# B-Pillar Lower Garnish Damaged

**Service Category** Vehicle Interior

Some 2006-2008 model year GS vehicles may exhibit gouging and scratching on the lower center “B” pillar garnish moldings. A countermeasured garnish molding has been developed to remedy this condition. This bulletin provides updated parts information and recommended repair procedures for replacement of both the RH and LH lower “B” pillar garnish moldings.

Figure 3.

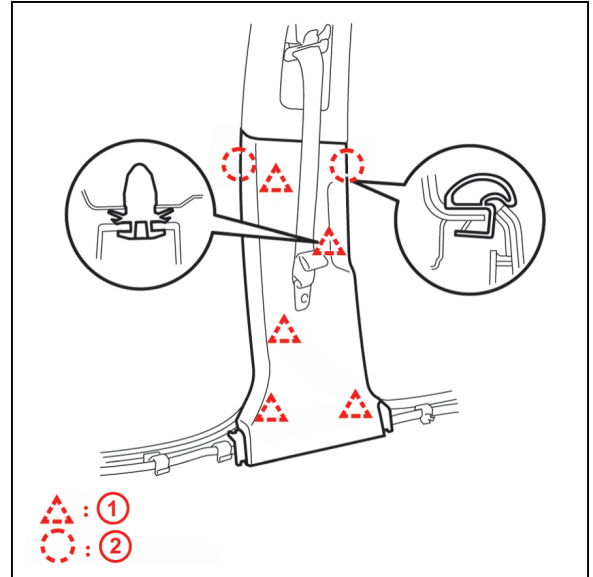
- Remove the center pillar garnish Lower LH

Detach the 2 claws and 5 clips, and remove the garnish.

PREVIOUS PART NUMBER	CURRENT PART NUMBER	PART NAME	QTY
62413-30211-A0	62413-30250-A0	Garnish Center Pillar, Lower RH	1
62413-30211-B0	62413-30250-B0		1
62413-30211-C0	62413-30250-C0		1

PREVIOUS PART NUMBER	CURRENT PART NUMBER	PART NAME	QTY
62414-30141-A0	62414-30180-A0	Garnish Center Pillar, Lower LH	1
62414-30141-B0	62414-30180-B0		1
62414-30141-C0	62414-30180-C0		1
